The 6th Regional Stakeholder Forum

Second Regional Information Sharing on Pak Lay Prior Consultation Process

Second Draft Technical Review on Navigation

Ms. Thi Thanh Yen Ton Nu, Navigation Operation Specialist, MRC Secretariat

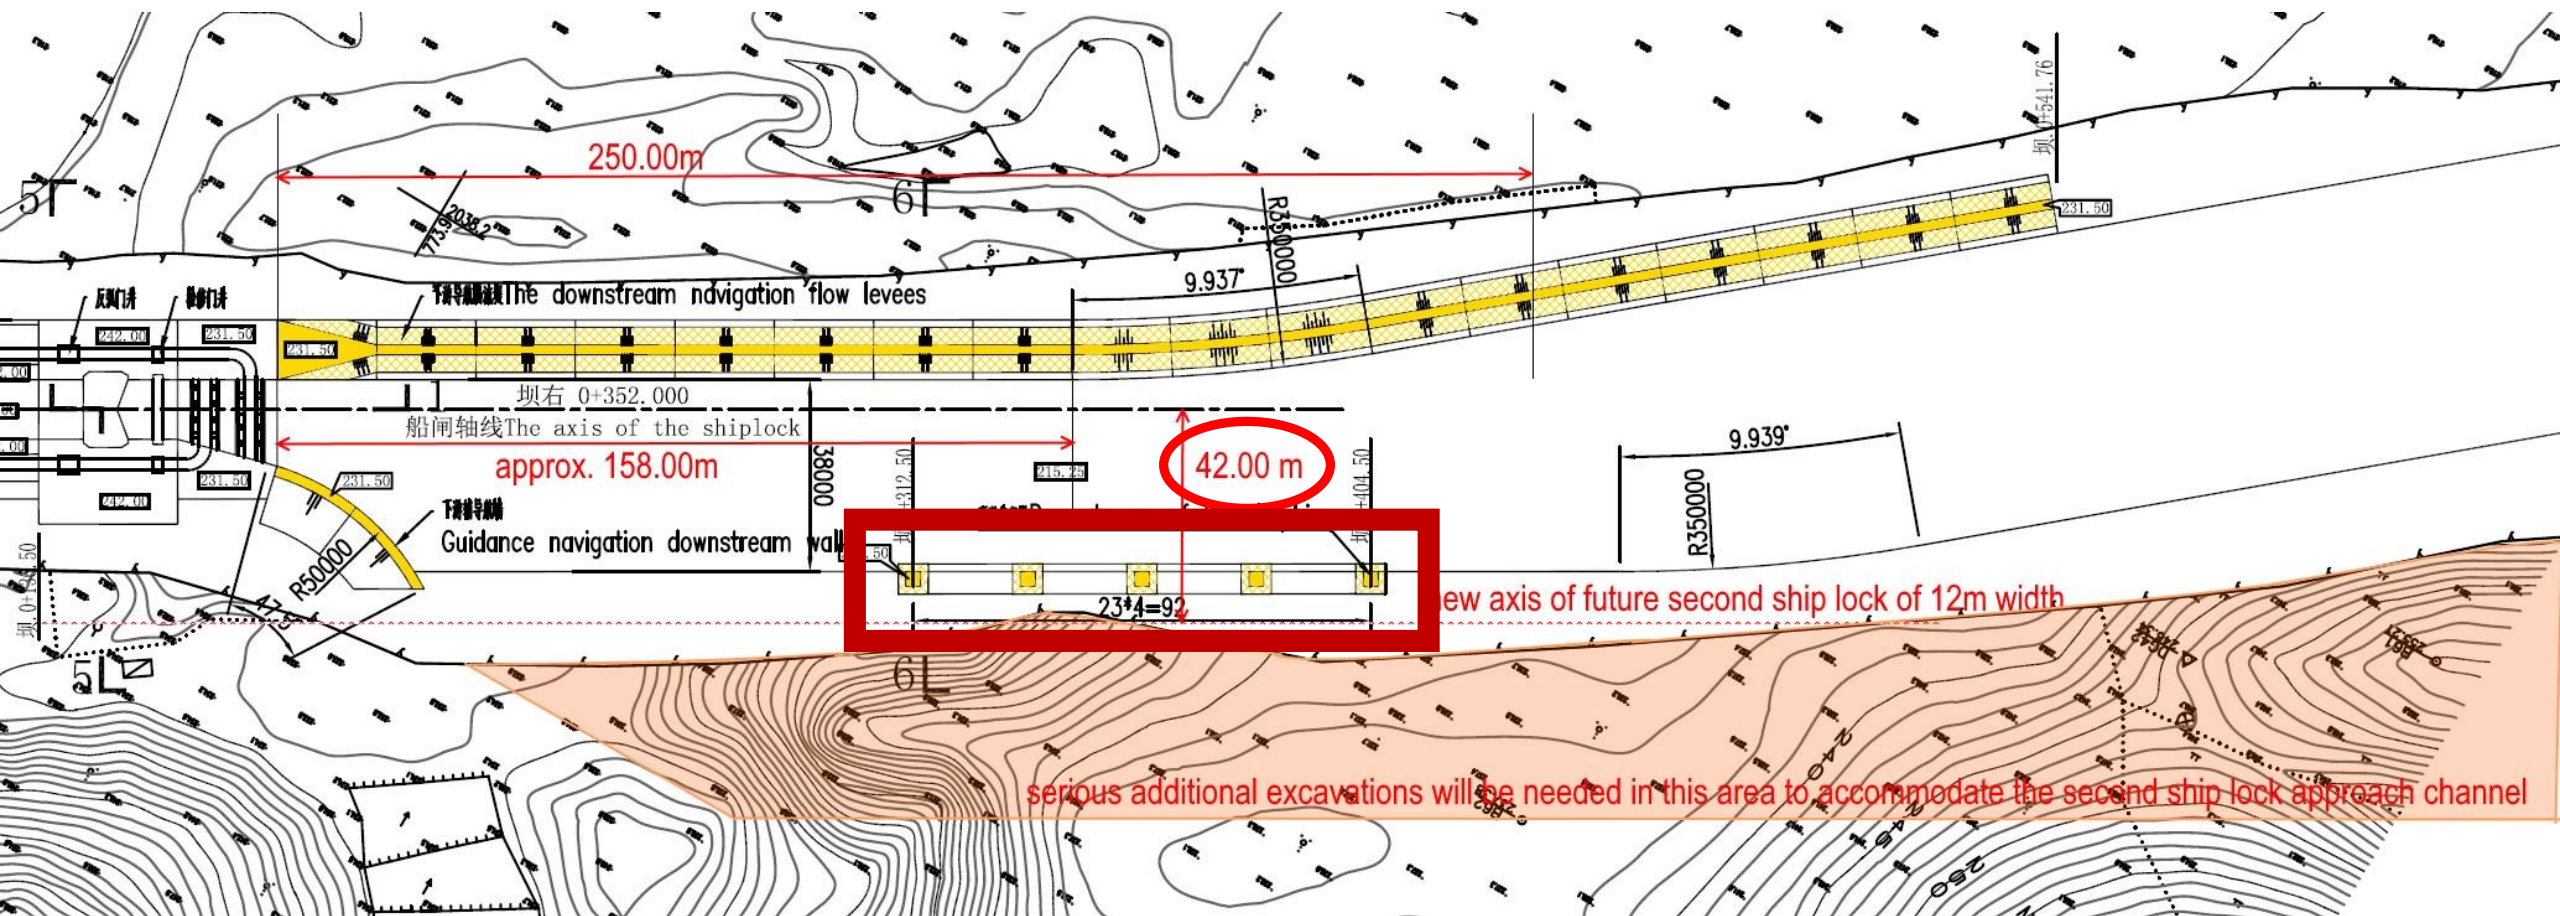
extra excavations to improve nautical access

OBSTRUCTING THE APPROACH TO THE FUTURE SECOND SHIP LOCK!!!

5. Reconsider the locations of the 5 dolphins up- and downstream that will hinder the entrance to the future second ship lock;
6. The downstream guidance wall should have a vertical front;
7. Redesign the downstream navigation channel including additional excavation works to accommodate future second shiplock access;
8. Road connections to all parts of the ship lock, also to the downstream lock head.
